Access Compliance Report

Public Rights-of-Way (Curb Ramps)

Intersection ID: 10013231	Main Street: MORNINGSIDE_DR	Cross Street: N/A	Location: E
ADA ID: C5AED7F9ECCB	Ramp Type: Perp	Initial Pass/Fail: Fail	Overall Compliance: No
		Severity Score: 25

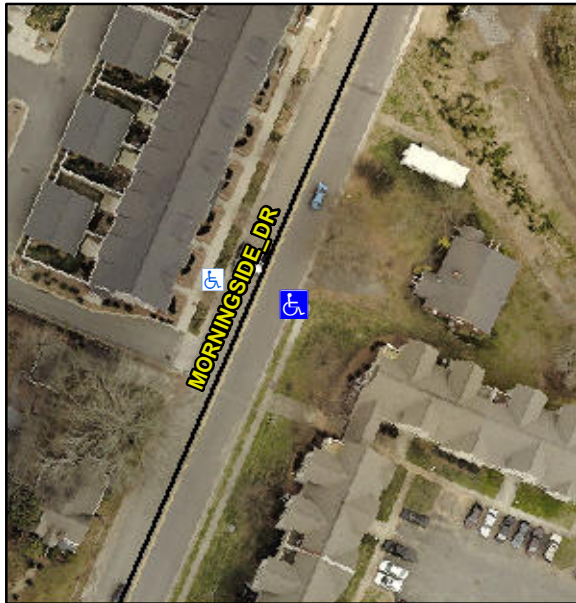
Not Found, R304.2.2

Compliance	Description	Data	Compliance	Description	Data
N/A	Ramp Length (in)	37.0	No	Ramp Slope (%)	14.8
Yes	Ramp Width (in)	48.0	Yes	Ramp XSlope (%)	1.5
N/A	Flare Type LT	N/A	N/A	Flare Type RT	N/A
N/A	Flare Slope LT (%)	N/A	N/A	Flare Slope RT (%)	N/A
N/A	Flare Traversable LT?	N/A	N/A	Flare Traversable RT?	N/A
N/A	Landing Length (in)	N/A	N/A	DWS Provided?	N/A
N/A	Landing Width (in)	N/A	N/A	DWS Contrast?	N/A
N/A	Landing Slope (%)	N/A	N/A	DWS Length (in)	N/A
N/A	Landing X Slope (%)	N/A	N/A	DWS Full Width?	N/A
N/A	Landing Curb? (Y/N)	N/A	N/A	DWS Offset (in)	N/A
N/A	Shared Landing?	N/A			
N/A	Gutter Ponding?	N/A	N/A	Gutter Slope (%)	N/A
N/A	Gutter Lip Ht (in)	N/A	N/A	Gutter X Slope (%)	N/A
N/A	Painted X Walk1?	No	N/A	Painted X Walk2?	N/A
	X Walk 1 Direction	To W		X Walk 2 Direction	N/A
N/A	X Walk 1 Width (in)	N/A	N/A	X Walk 2 Width (in)	N/A
	X Walk 1 Slope (%)	2.2		X Walk 2 Slope (%)	N/A
	X Walk 1 X Slope (%)	2.6		X Walk 2 X Slope (%)	N/A

Remove & Replace Entire Ramp.
